**Submission to Standards New Zealand
with regard to
draft Standard DZ 6808:2009
Acoustics – Wind farm noise**

**from
Philip J Dickinson Ph.D., FASA**

Figure 1

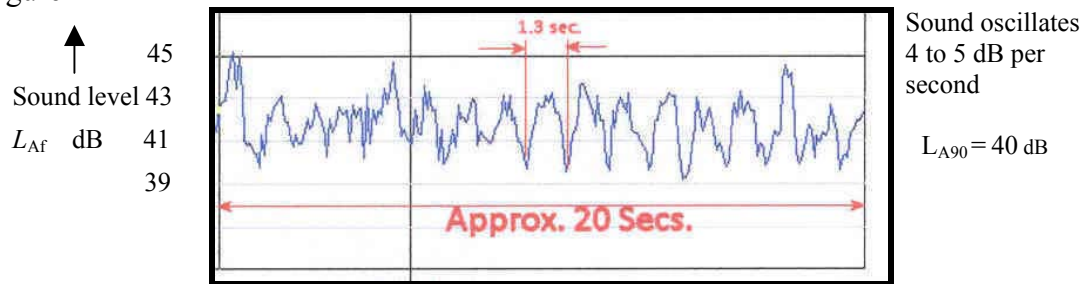
Figure 1 [6] shows a typical windfarm noise time history over a few seconds. The L90 in this case is about 3 dB below the average maximum level (L10) but in many cases it is about 5 dB below. So in many windfarm standards across the world (including this draft) the design criteria is set as an L90 of the background level + 5 dB or 40 dB whichever is greater – again theoretically the maximum one can get away with, without there being very severe repercussions from the community. At such levels there will be severe annoyance, but most people will knuckle down realising that there is almost nothing they can do about it without it costing them quite a lot of money. It does not limit annoyance and it does not protect public health.

Figure 8

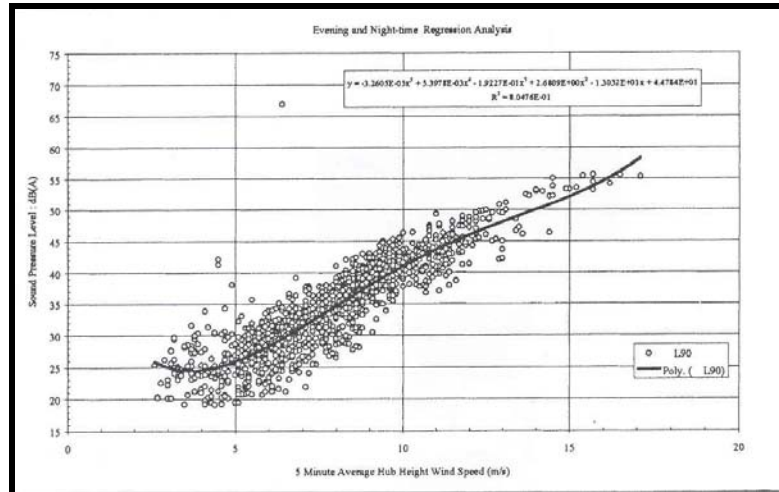
Figure 8 shows a plot of such data pairs as would be produced for a windfarm resource consent [8]

The graph compares a 10 percentile level (L_{A90}) with a linear parameter and then takes a 50 percentile regression line on which to base the alleged relationship between the background sound level at the recipient property with the wind speed at the hub of the turbine which may be on an elevated position some distance away. Not only is there such a wide scatter of data pairs – more than 15 dB on several occasions – but using a 50 percentile regression line for a 10 percentile function rather than a 10 percentile regression line, artificially raises the value of the background sound level and is mathematically incorrect. If such a regression line is to be taken, and the computer program used to analyse the data does not contain the means to use such a regression line, then one standard deviation below the 50 percentile regression line would be nearer the truth.

Figure 9

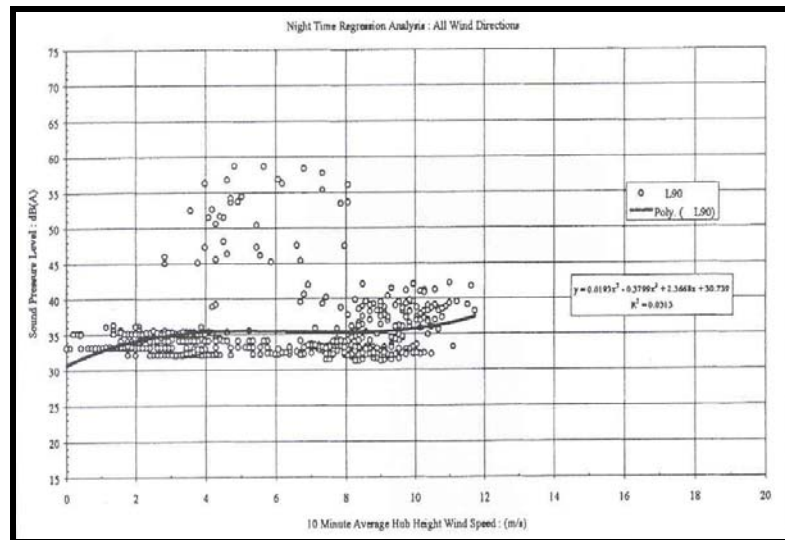
On this graph there is an even greater scatter – more than 20 dB on several occasions – but more worrying is the possibility that the instrumentation used in the unaccompanied monitoring has not truly measured the background sound level at all.

First of all it would appear that the instrumentation did not have a sufficiently low noise floor to record all the sounds at their true level. It will be noticed there is no scatter of results below 32 dB, but tremendous scatter above 40 dB. This suggests the noise floor of the instrumentation used was as high as 32 dB, so anything below 28 dB was recorded as 32 dB or anything between 28 and 32 dB recorded as 33 dB or over. The background sound level may well have been well below 25 dB, even below 20 dB, but the instrumentation has recorded it as being 32 dB. This has artificially raised the value of the background sound level possibly by several dB. It may be noted that some of the equipment seen to be used by noise consultants in New Zealand for such purposes, has this limitation.

Figure 10

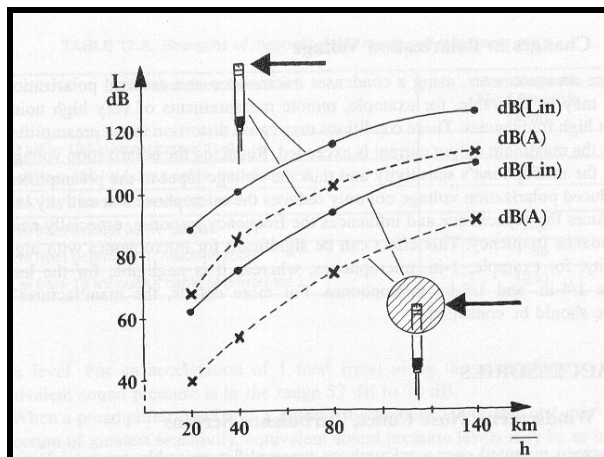
measuring sounds between 30 dB and 40 dB, even with a good windshield in place. Figure 10 below shows the effect of a wind shield on a sound level meter [9]. If the wind at the microphone is 20 km/hr, the sound level meter will register 40 dB without any other sound present even with a windshield in place.

The draft Standard places no limits to the wind speeds in which the measurements are to be taken. If the wind is over 5 metres per second, much of the measurement will be noise from the wind on the microphone and not the background level at all – even with a very good windshield in place. The background sound level is being artificially raised even more – again to the benefit of the noise maker. Such rank manipulations would not be acceptable from any other industry so why is it allowed in the current standard for windfarms and carried over into the new draft? It is mathematically, scientifically and ethically wrong
